May 20, 2015

Ms. Helen Donaldson
Planning and Development Department
City of Portland, Maine
389 Congress Street
Portland, Maine 04101-3509

**Subject: Century Tire Plaza – 195 Kennebec Street
Project ID# 2015-027
Review Comments Received May 7, 2015**

E1.00

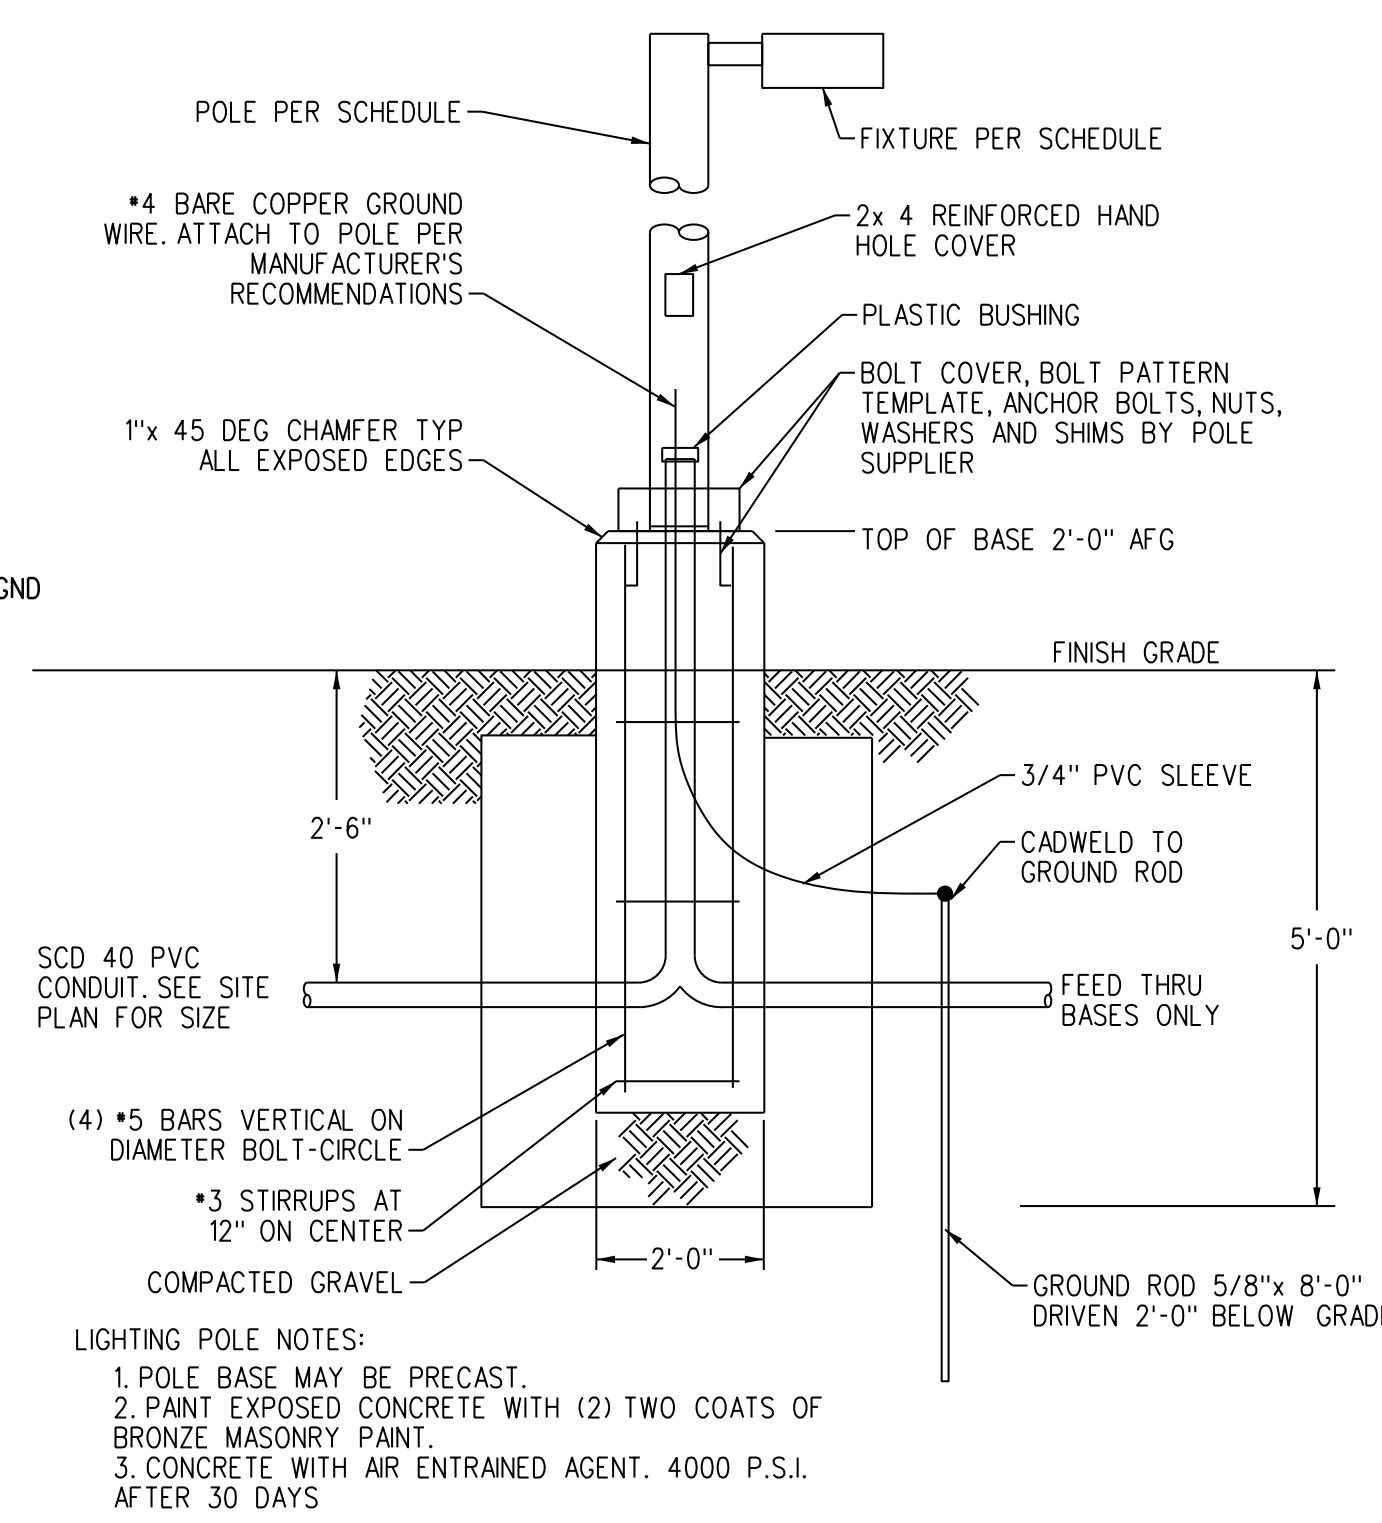
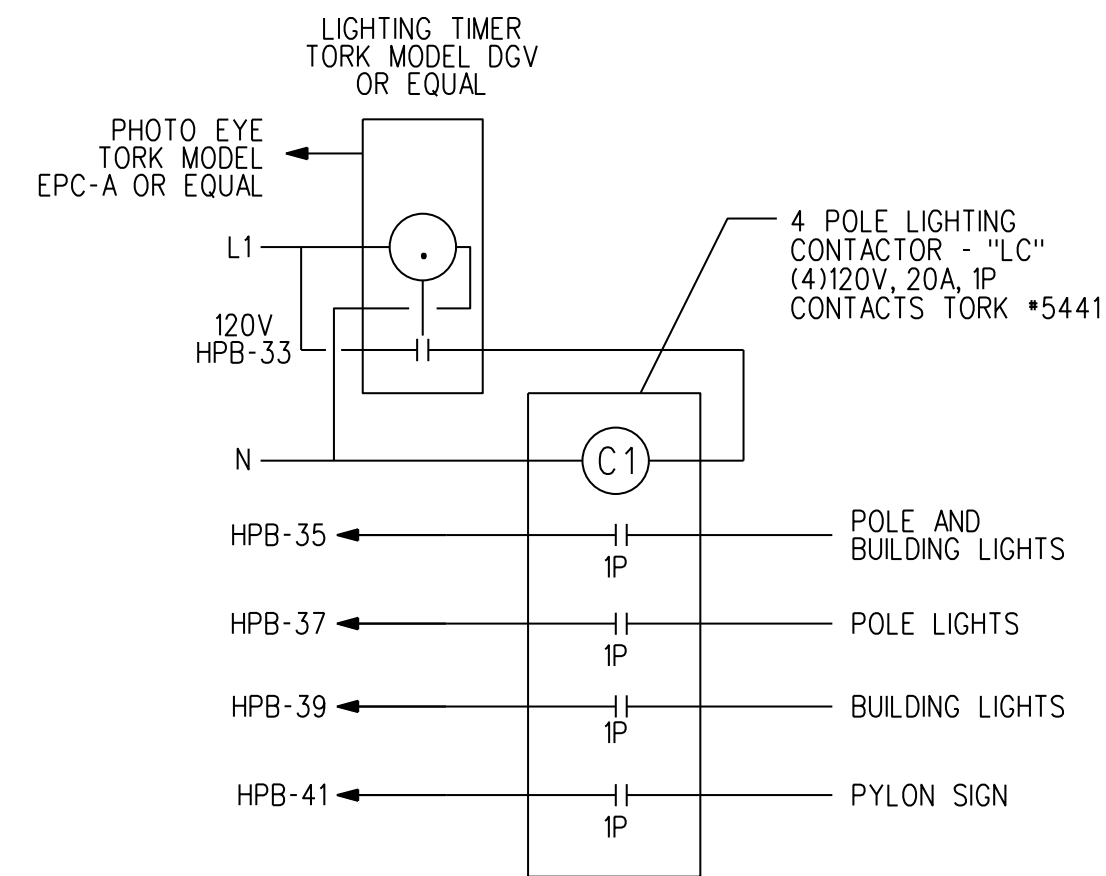
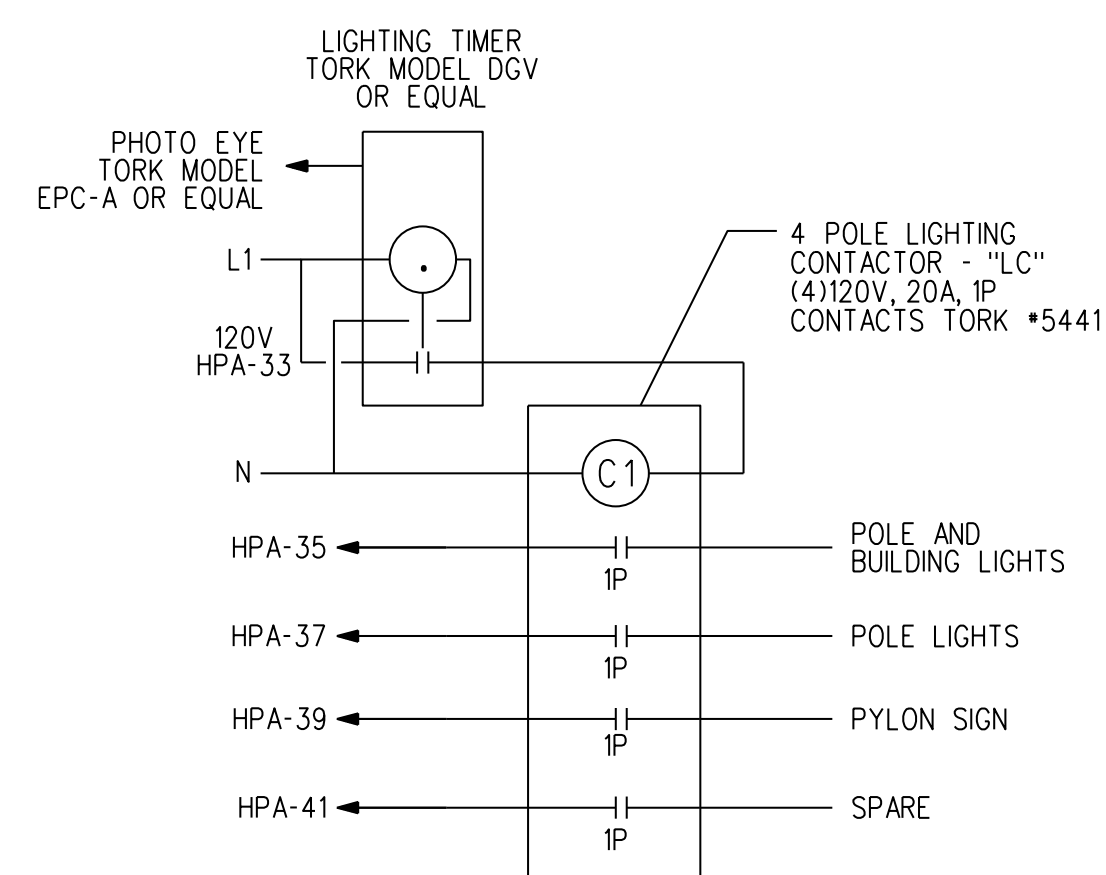
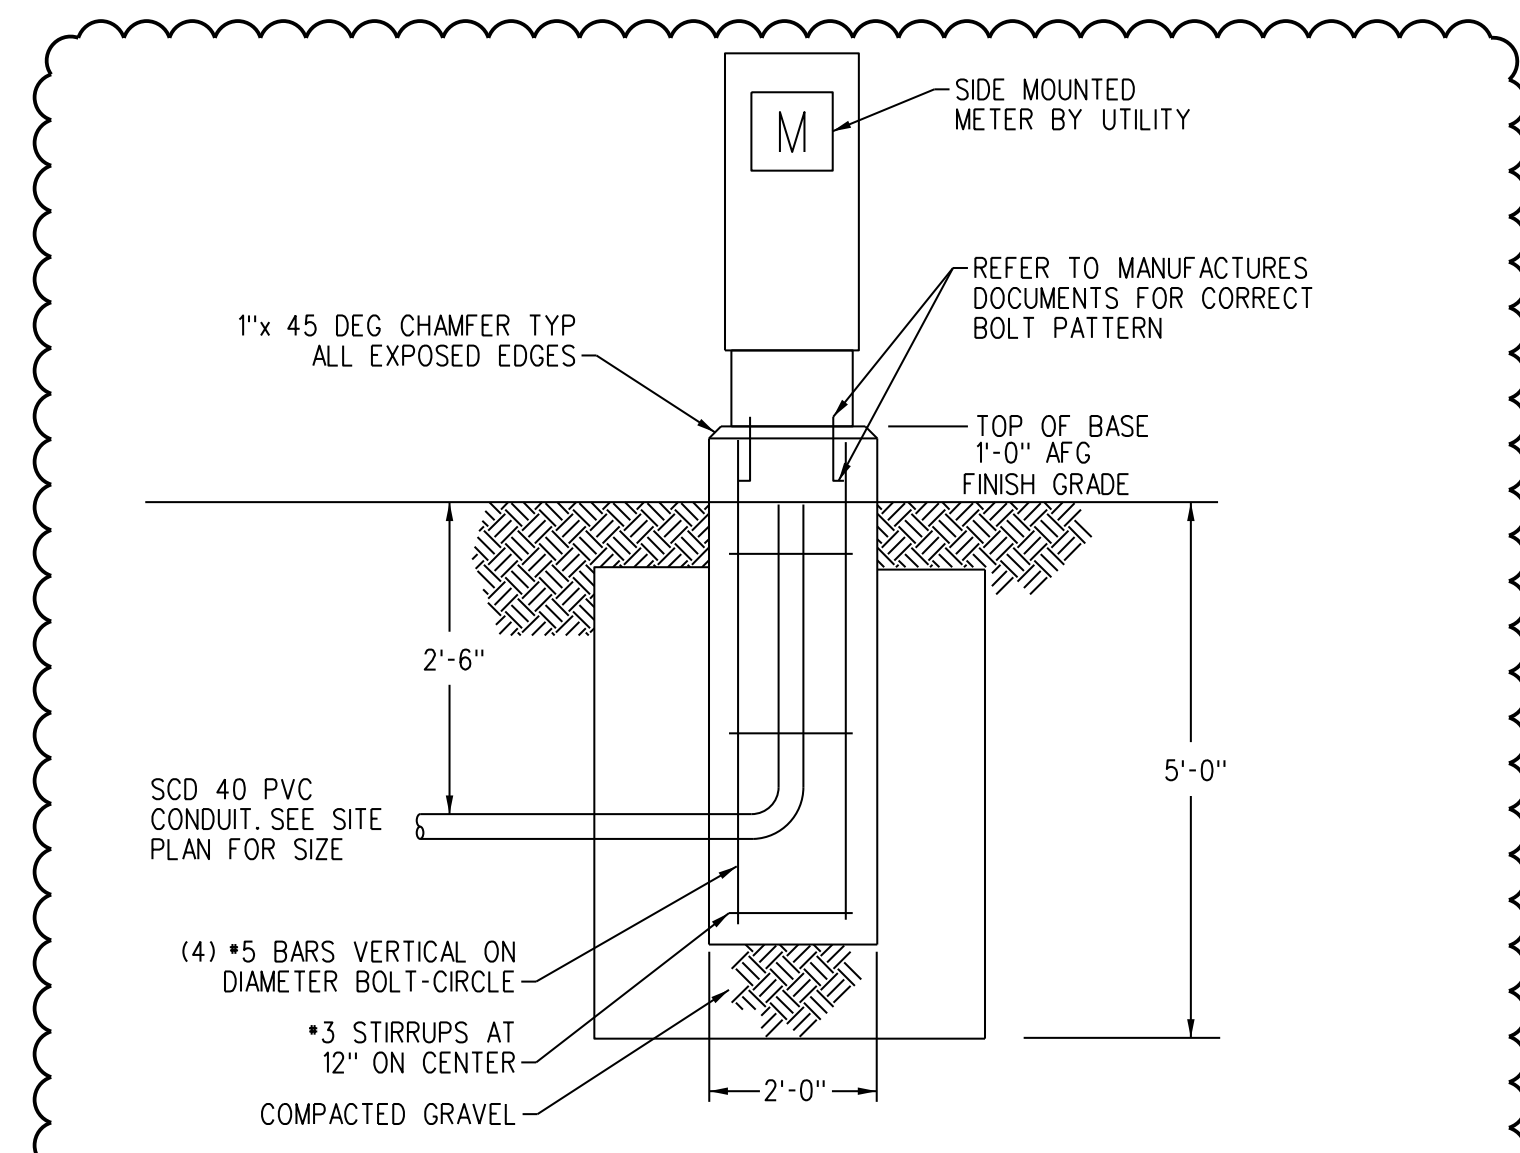
- 1. On Marginal Way, where does the proposed electrical conduit connect to the existing lighting circuit? Show the location and details of the connection. Show the location of the conduit to be installed.*

- 2. On Kennebec Street, show connection from the proposed meter to the utility power grid. Show the electrical panel design details.*
- 3. Specify the conduit size, type, and provide installation detail showing the depth of cover (minimum of 36"), conduit encasement, and marker tape.*

- 4. Specify and show the conduit location with respect to right of way or some other reference.*
- 5. Are light fixtures, poles, and pole foundations details provided?*

- 6. The applicant will be responsible for all connections, wiring and any other ancillary work required for a complete street project. Please delete reference that the City is responsible for such work.*

- 7. It is understood that all street lighting will have LED fixtures, all circuits metered for City billing and please not that a 120v outlet per pole is not required*

Please see revised electrical plan from Bennett Engineering that addresses these comments.

DRAWN: ADJ DATE: 11.25.14
DESIGNED: ADJ SCALE: 1" = 20'
CHECKED: ADJ JOB NO.: SP-M160
FILE NAME: SP-M160 BASE
SHEET: **C-3.0**

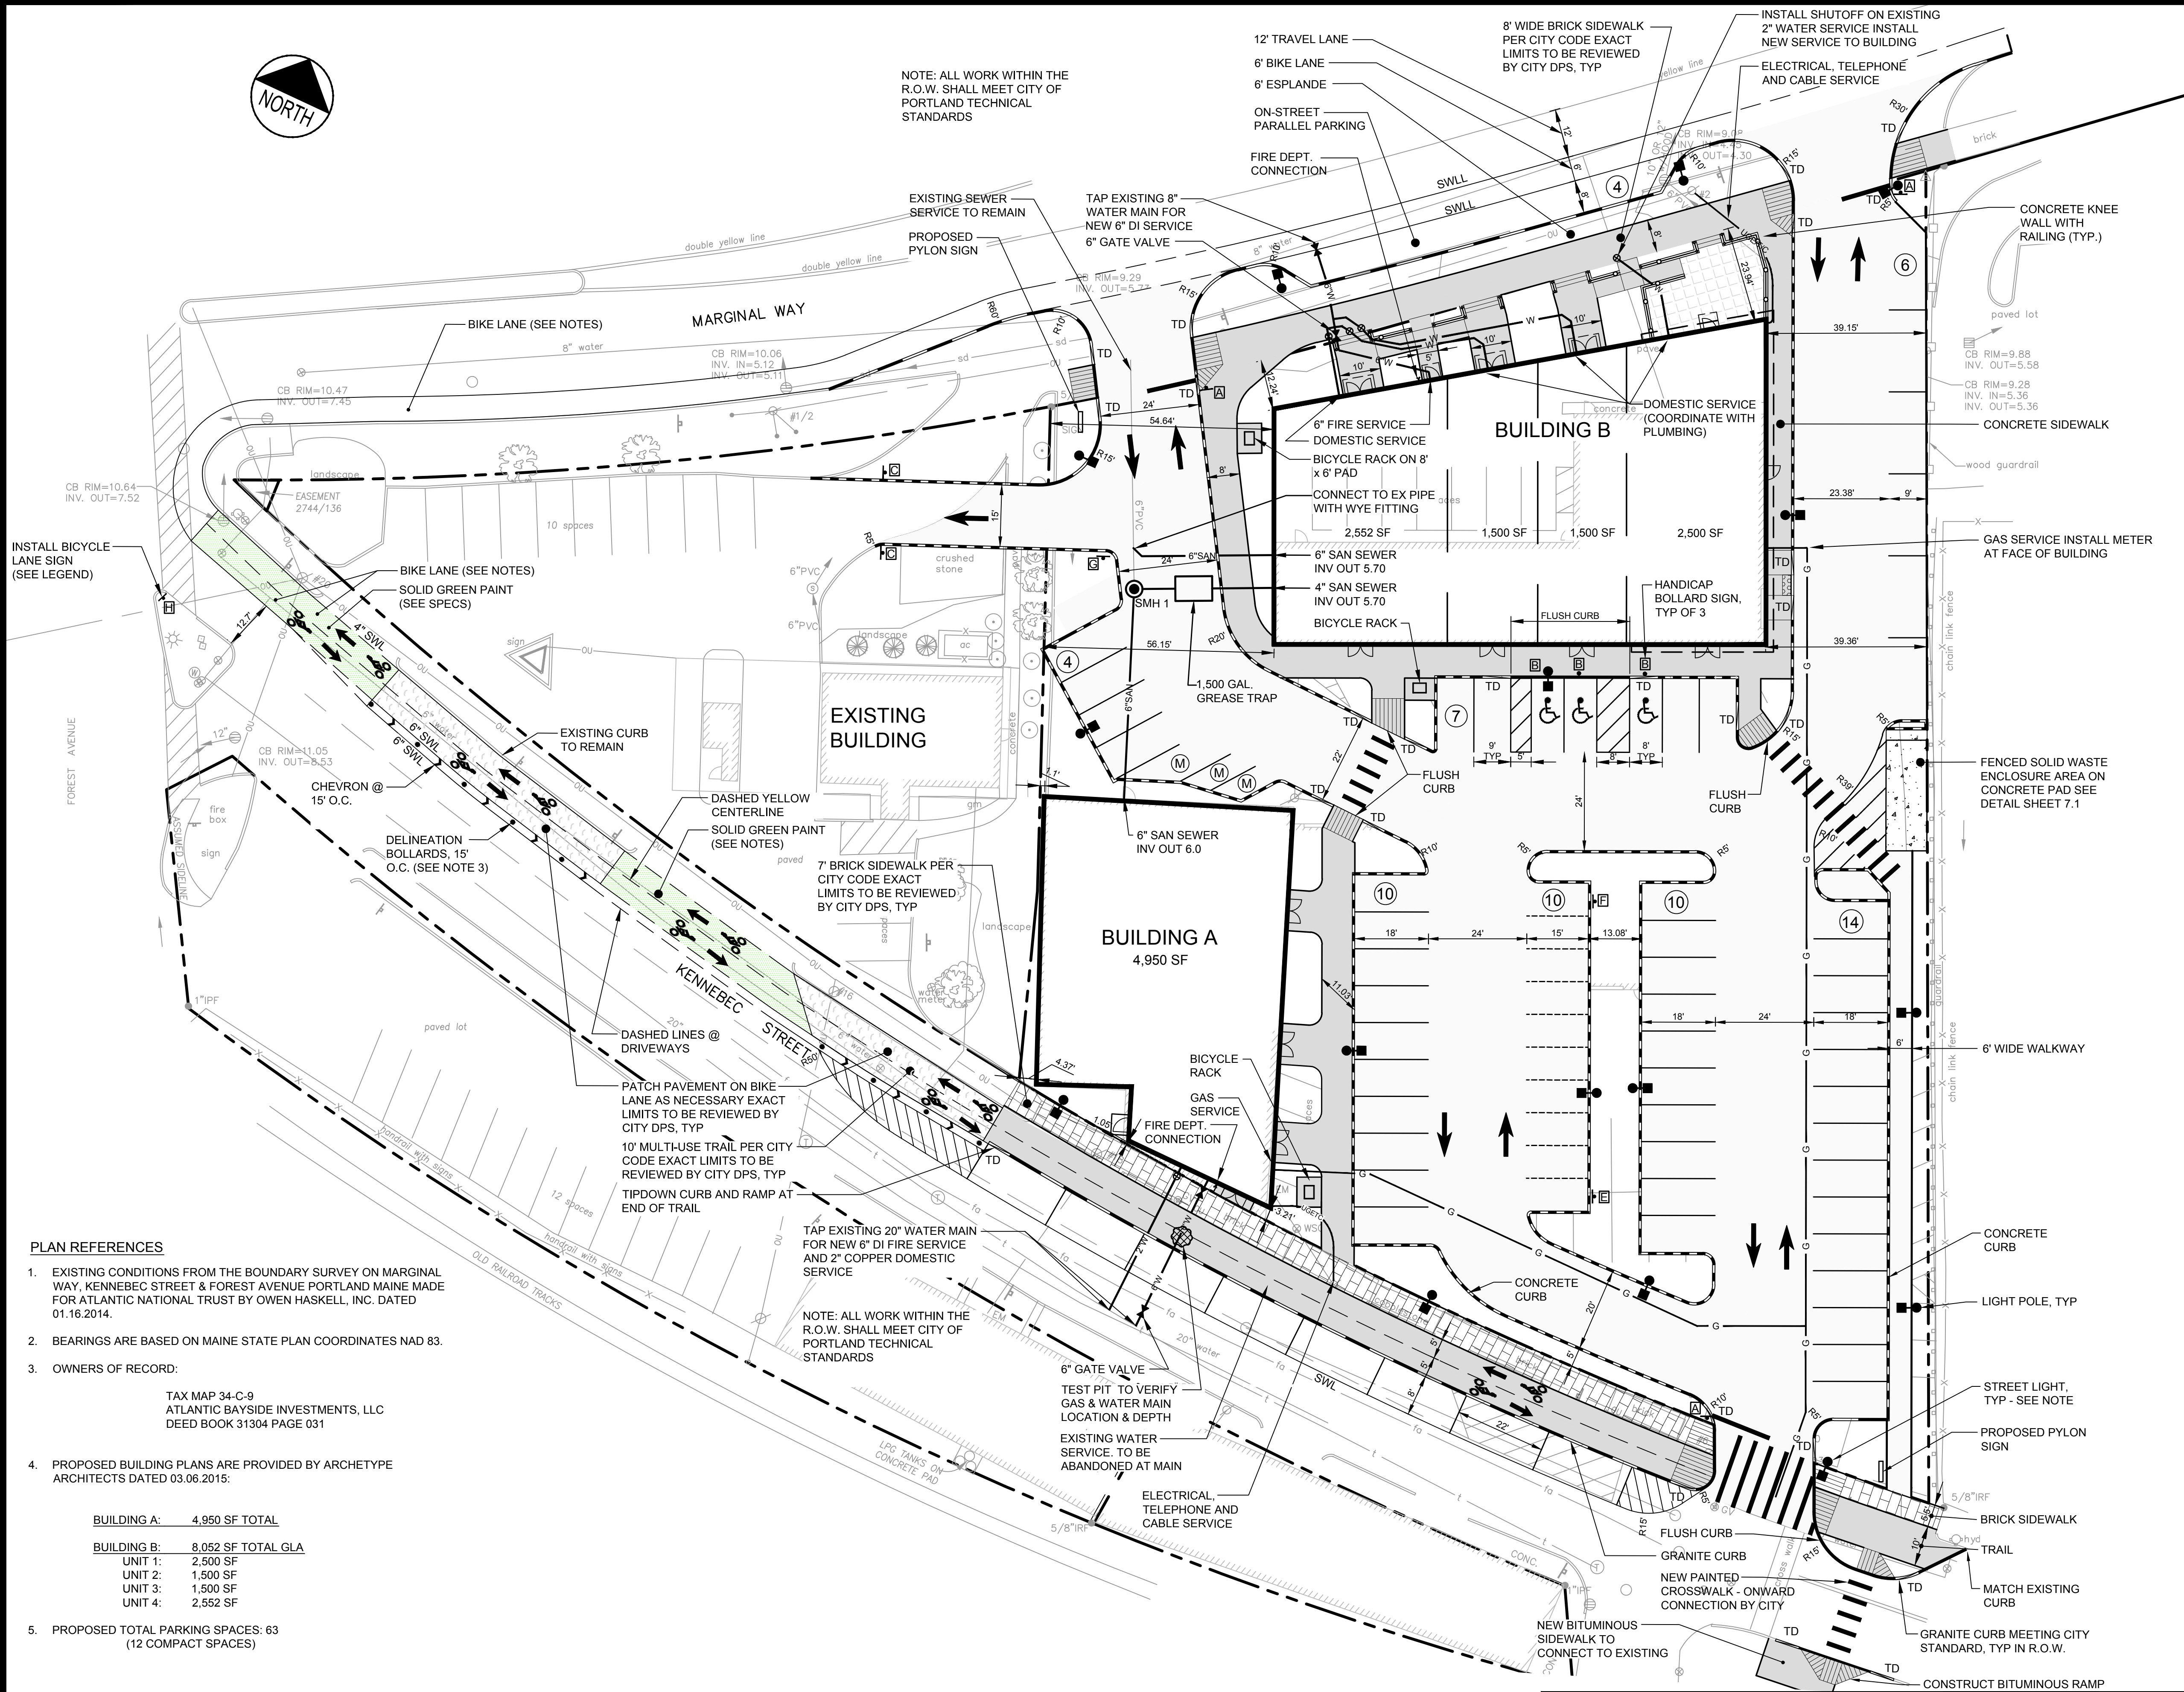
5/7/2015 Status: I find the revised configuration of the parking spaces to be acceptable with the removal of the parking space nearest Marginal Way.

The green paint shall extend all the way to Forest Avenue from the Enterprise driveway. Attached is the green paint product that should be installed.

There should be a 4" yellow dashed line dividing the cycle track with bike lane markings (helmeted cyclist and arrows) indicating a two-way cycle track.

The attached sign shall be installed at Forest Avenue/Kennebec Street intersection on that corner illustrating two-way bicycle traffic to motor vehicles. The sign size shall be 24" x 24".

Bollards shall be spaced 15 feet apart. Green colored 42-inch high bollards should be installed per the attached standard.

The 2-foot buffer between the parked vehicles and the raised path needs to be removed per Fire Department comments (they are fine with the bollard area).

The buffer space shall have chevron markings. A six-inch white gore line should be provided every 15 feet.

The outside line of the cycle track shall be 6" wide and the inside line shall be 4" wide.

The dashed lines at the driveways shall be a 2-foot stripe with a 2-foot gap.

The lights on Kennebec Street should be the medium Bayside fixtures, and I believe your specs are correct, but you list the lights on both streets as 'large scale' on the site plan. Could you revise your note to clarify this?

The parking space nearest Marginal Way has been removed on the revised plan sheet.

The location of the green paint has been modified as requested to extend to the Forest Avenue intersection.

A yellow dashed centerline has been added to the bike lane as requested.

The sign has been added on the revised plan sheet.

Delineation bollards have been added in the buffer zone between the bike lane and the travel lane, as requested.

The buffer zone has been eliminated alongside the raised path at the request of the Fire Department. It should be noted that this creates a potential conflict between open car doors and bicyclists traveling along the raised path.

Chevron markings at 15-foot intervals have been added along the buffer zone, as requested.

The revised plan shows the striping designation, as requested.

Dashed lines are shown and noted on the revised site plan. A note has been added indicating all snow will be removed from the site.

The note has been revised on the plan sheet to reflect the correct designations for the light poles.
